PROJECT: C-8625  
SR 520 West Approach Bridge North Project

SUBJECT: **CO # 72 – Marine Casing Ext and Misc**

**WASHINGTON STATE  
DEPARTMENT OF TRANSPORTATION  
CHANGE ORDER**

CONTRACT NO: 008625 FEDERAL AID NO: BR-NHPP-0520 (053)  
CONTRACT TITLE: SR 520, MONILAKE TO EVERGREEN PT. BRIDGE WEST APPR  
CHANGE ORDER NO: 72 MARINE CASING EXT AND MISC

BELVEDERE AND EQUIPMENT PLATFORM  
BELVEDERE ELEVATION & SECTIONS

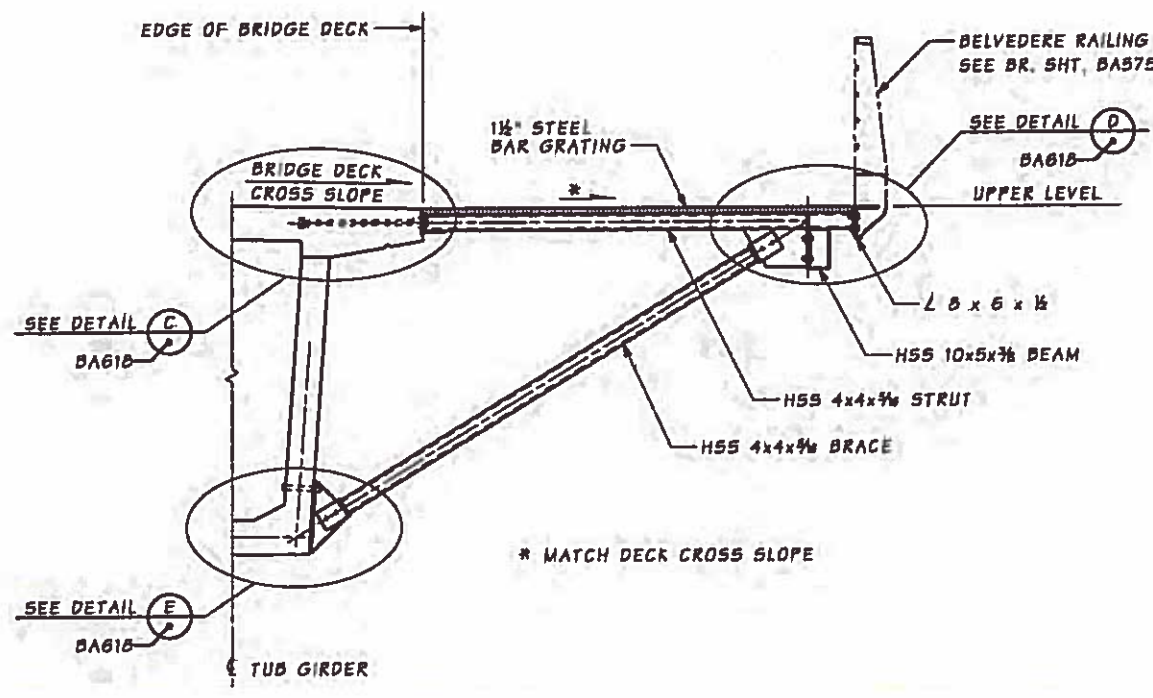
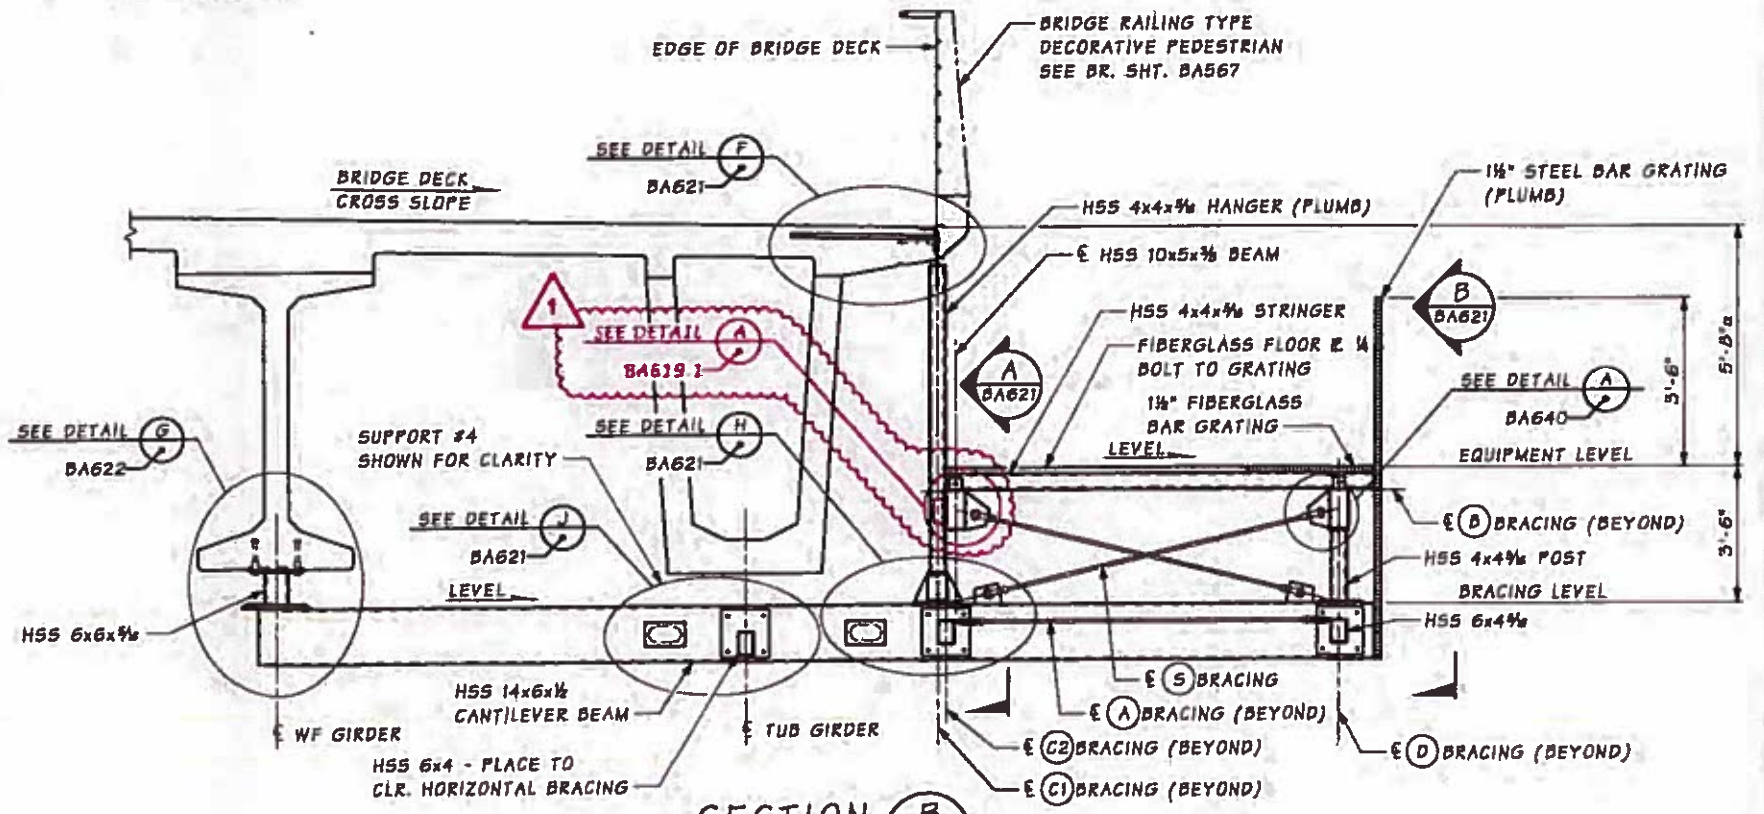
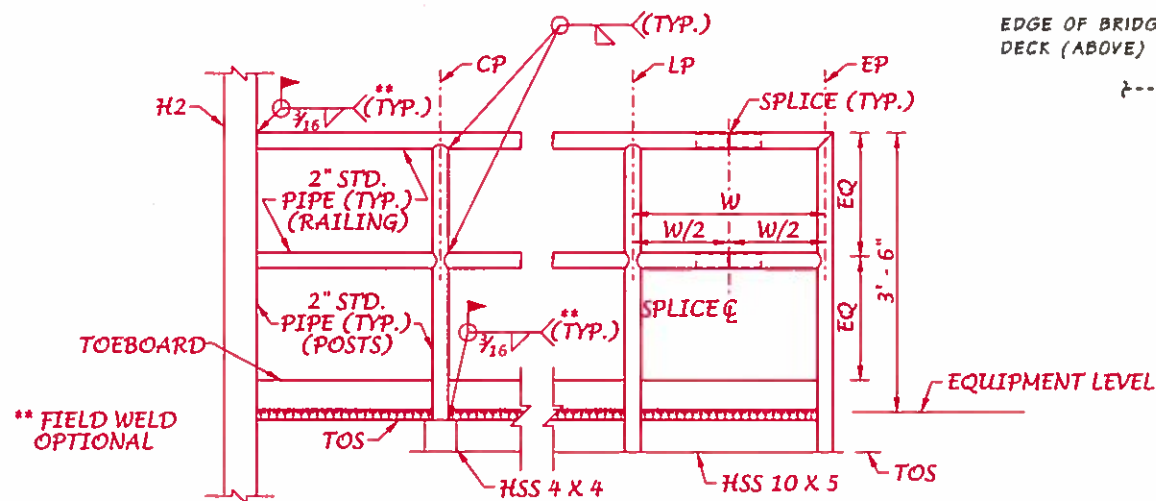
1. Extend the permanent shaft casings for Piers 34 through 41, to ensure the casings advance adequately into dense soil.
2. Delete Contract Work that is no longer required as a result of the prematurely demolished Sign Bridge No. 520/1.76E (SB00404) and deletes the requirement for the removal of the existing Dynamic Message Sign (DMS) in the vicinity of Foster Island. Destruction and replacement of Variable Message Sign (VMS) 520vm00177 was addressed under CO #048 SR520 Closure Costs. Disadvantaged Business Enterprise (DBE) participation for this item is adjusted as detailed below.
3. Replace the galvanized bar grating screen on the south side of the equipment platform belvederes at Piers 16, 21, 28 and 36 with railing and toe plate.

Plan sheets BA617 titled "Belvedere and Equipment Platform Belvedere Elevation and Sections" and BA617.1 titled "Belvedere and Equipment Platform Belvedere Framing Plan 2" are deleted and replaced with pages 19 through 20 of this change order.

BRIDGE SHEET NO. BA619.1  
SHEET 1555.1 OF 1797 SHEETS

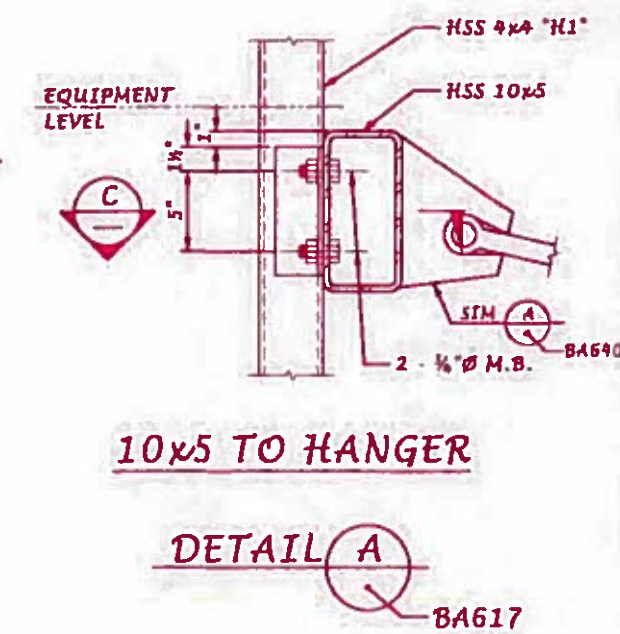
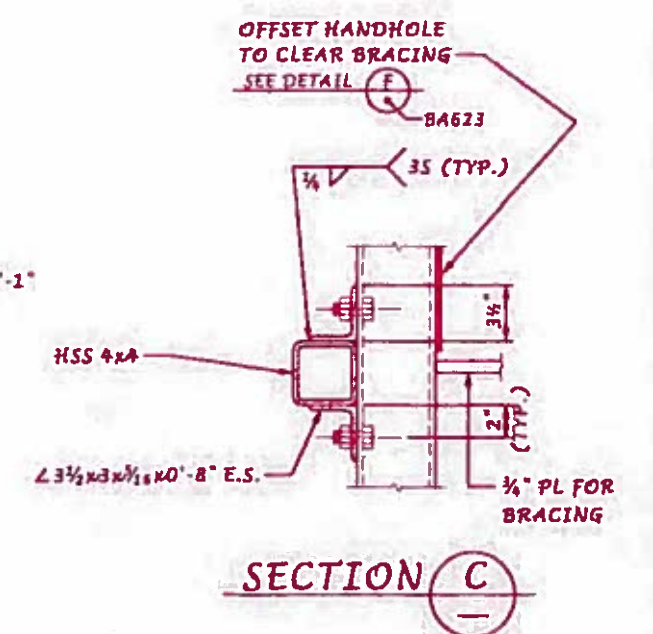
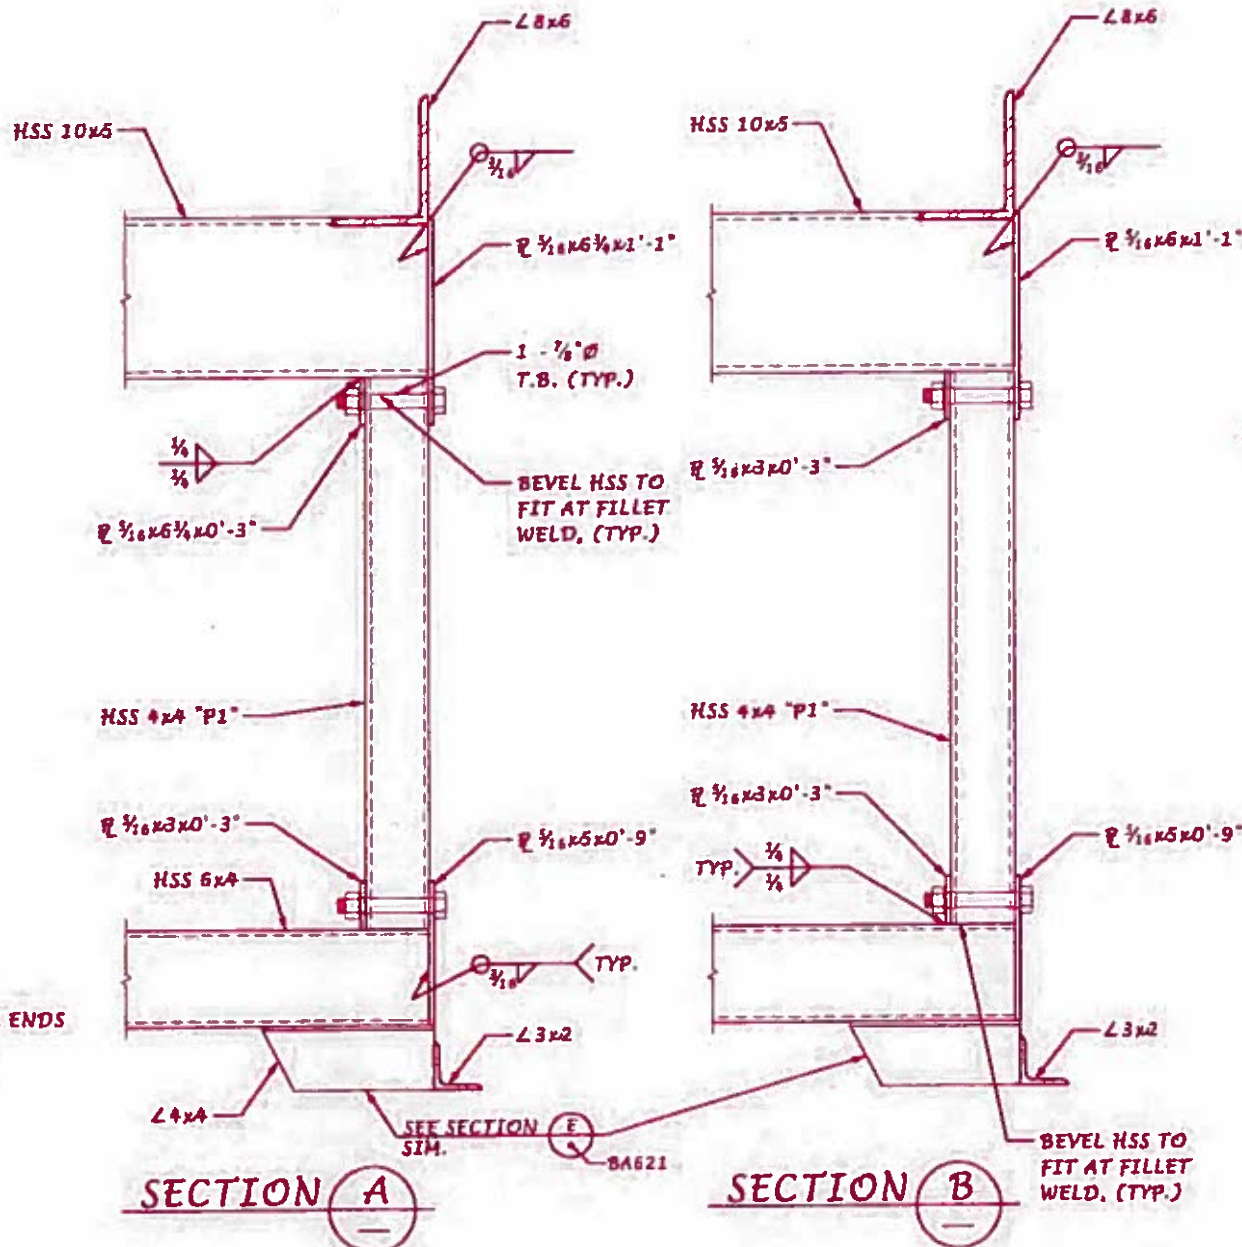
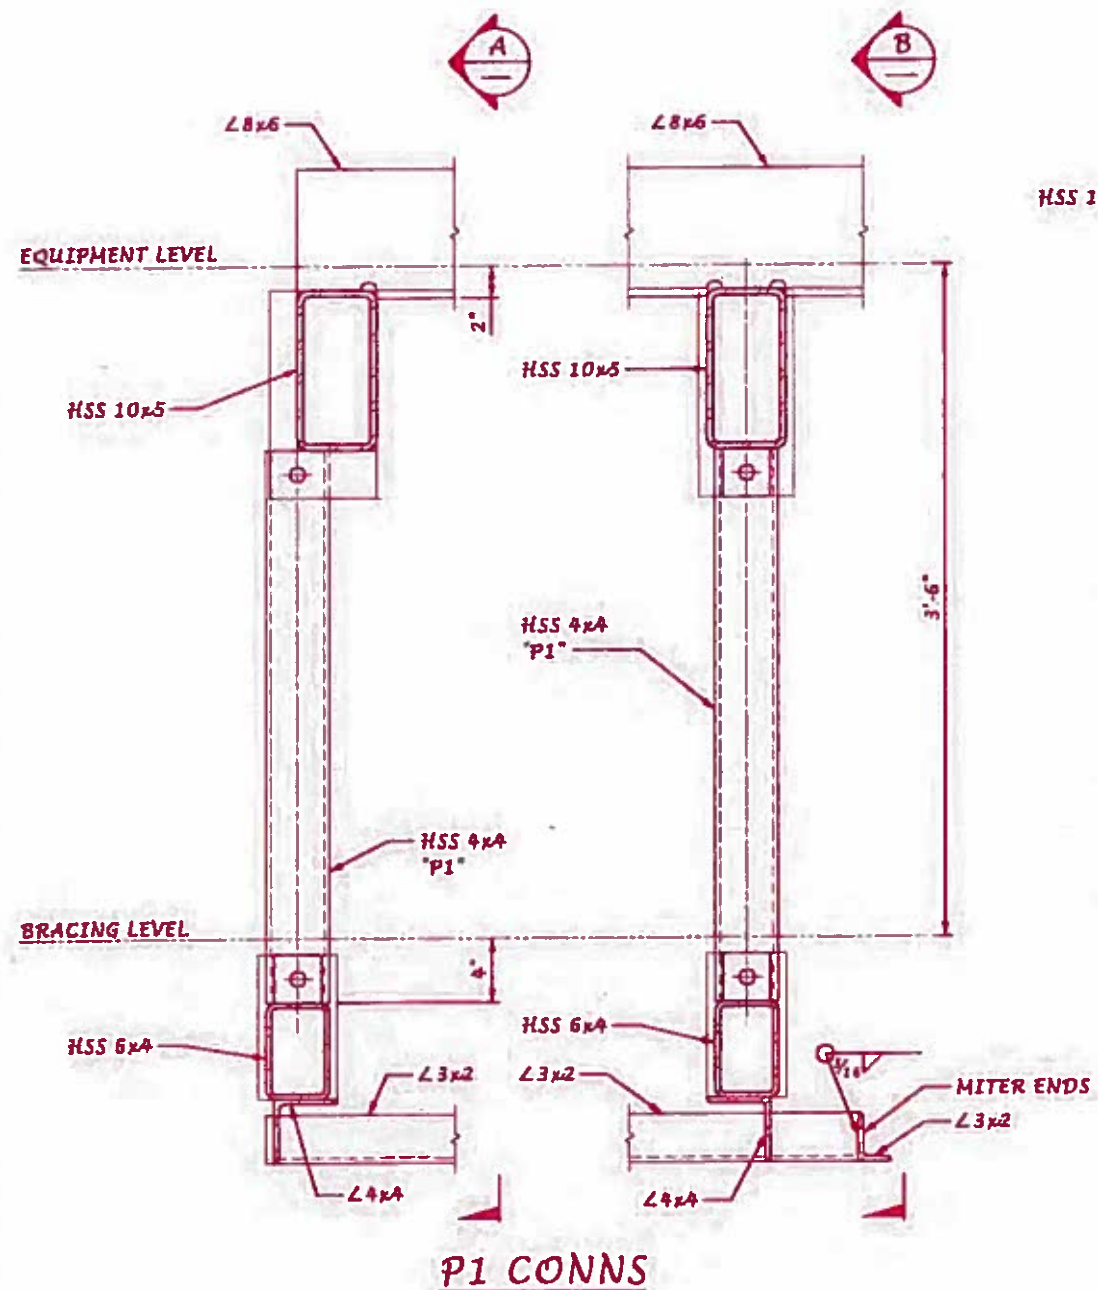
Add plan sheet BA619.1 titled "Belvedere and Equipment Platform Belvedere Framing Details 2" and included as page 21 of this change order.
